RE: 2113 Coal Ave. SE

> **Grading and Drainage Plan** Engineer's Stamp Date: 03/04/21

Hydrology File: K15D106

Based upon the information provided in your submittal received 03/09/2021, the Grading and Drainage Plan is approved for Grading Permit.

DRAINAGE PLAN

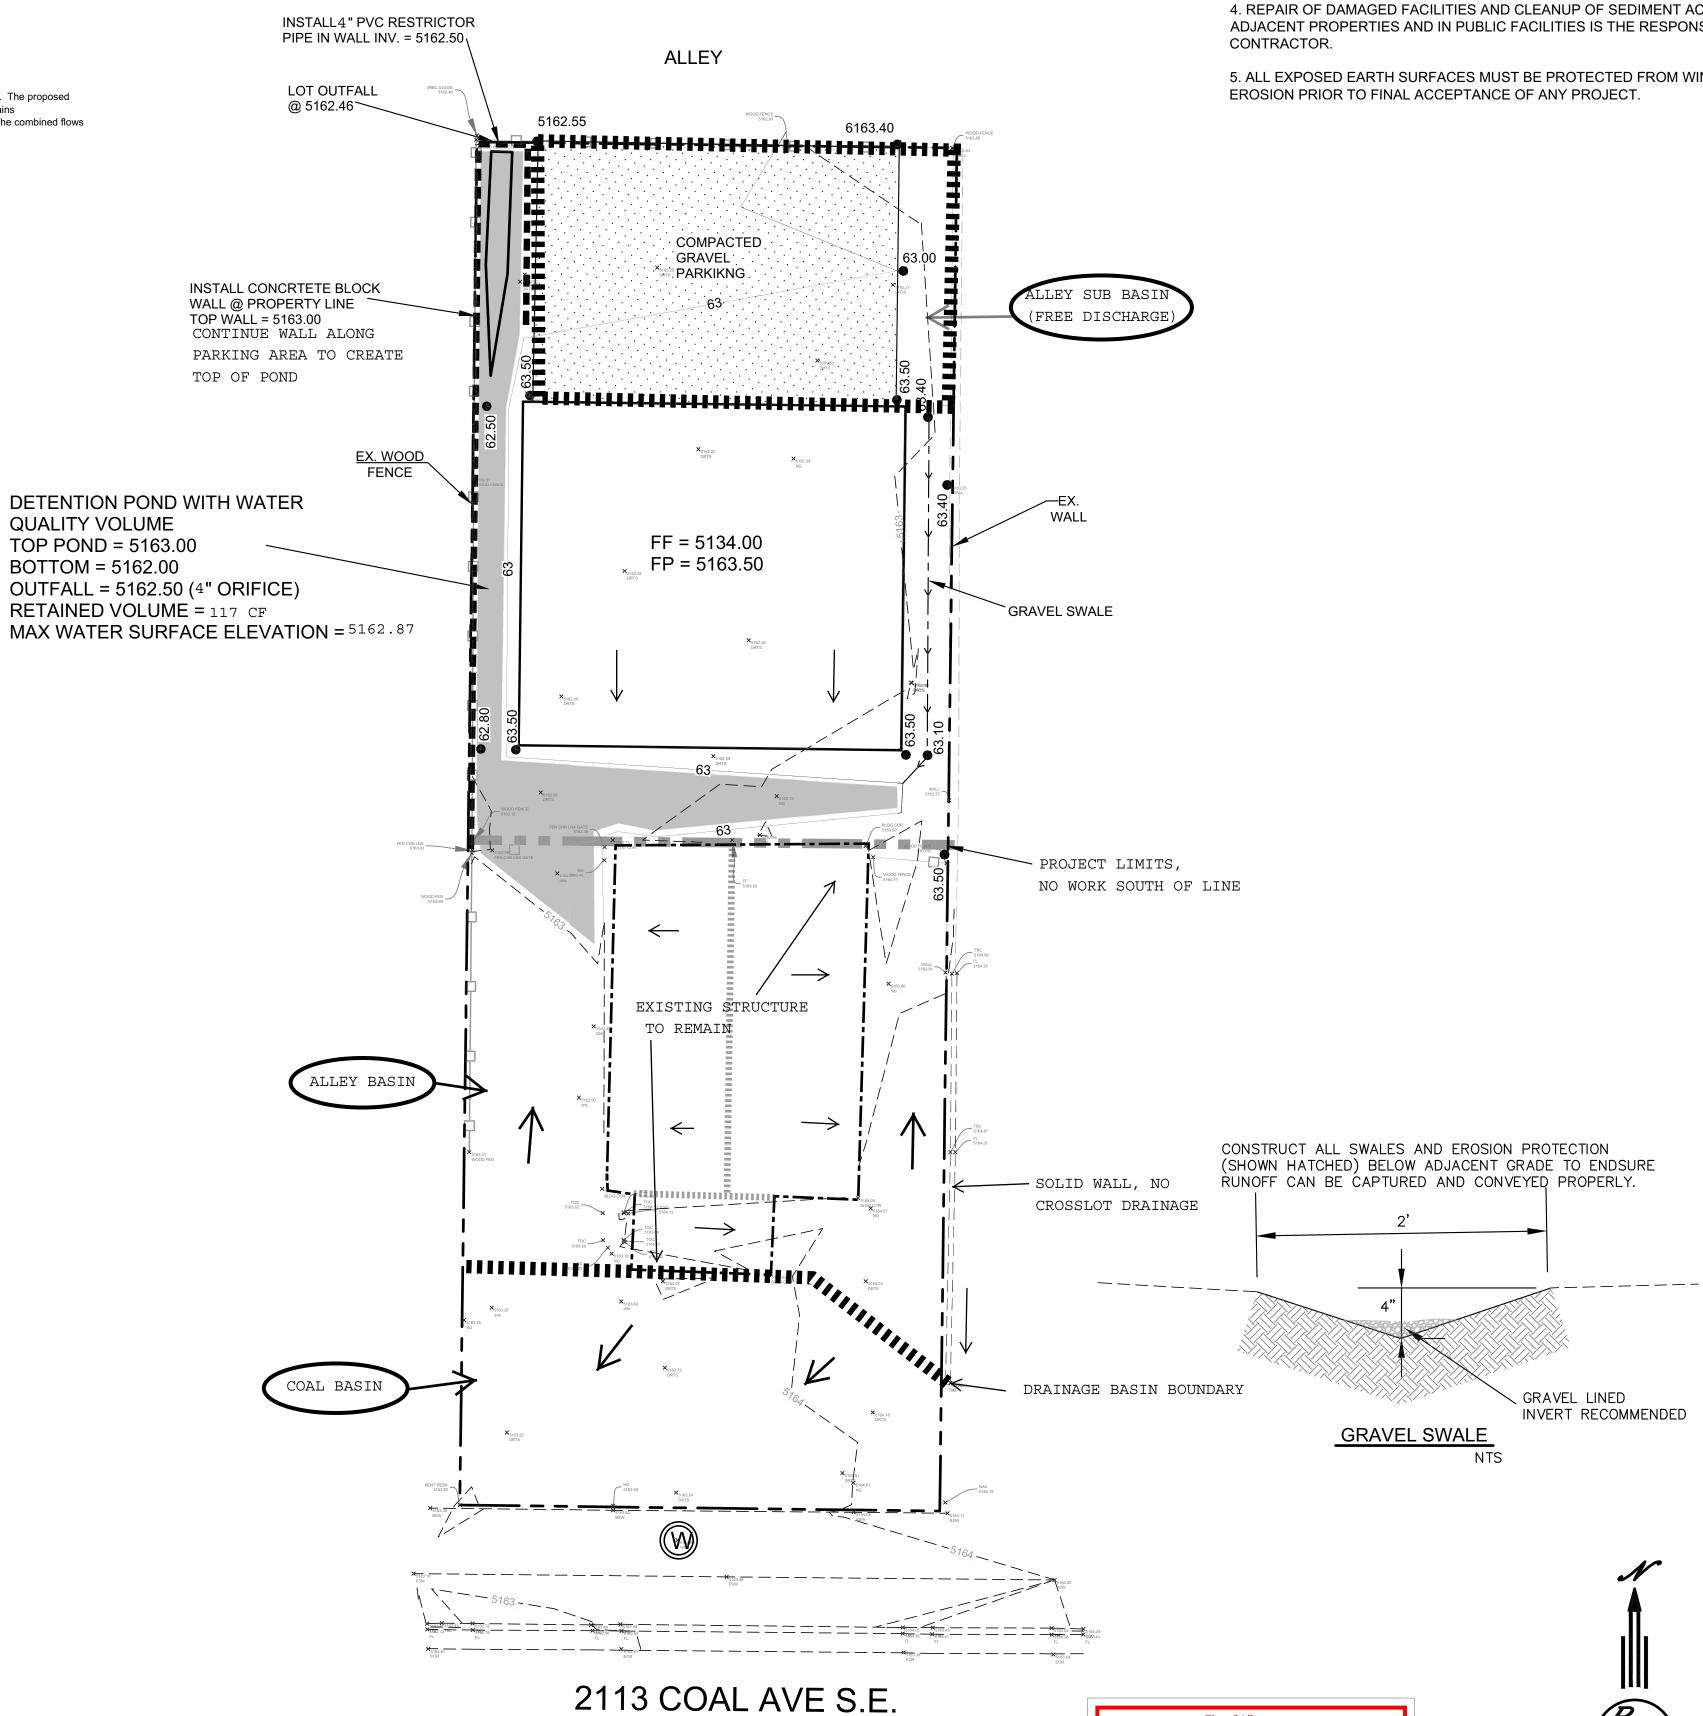
I need the following information prior to approving this project. Please let me know. Also please change your address to Coal Place SW. Coal Ave diverts to the south prior to the site.

Alley survey information????? I need existing grade information at least 20 feet east and west of the prope lines. I think the alley slopes to the west but I need so confirmation. Also what is the condition of the alley a this location? I know further to the east the alley is ok further to the west the alley is ok. However right here looks like gravel which would have to be brought up to City standards. INSTALL 4" PVC RESTRICTOR PIRE IN WALL INV. = 5162.50 ALLEY LOT OUTFALL @ 5162.46 5162.55 COMPACTED GRAVEL! **PARKIKNG** NSTALL CONCRTETE BLOCK **NALL @ PROPERTY LINE FOP WALL = 5163.00**

Renee, The surveyor did not pick up additional alley shots. I have attached pictures from a site visit. The alley slopes from east to west discharging to Buena vista west of this site. The alley grading is not consistent, but with fencing and grades all the flow stays withing the alley, the grade of alley adjacen to this site is 1.6% David
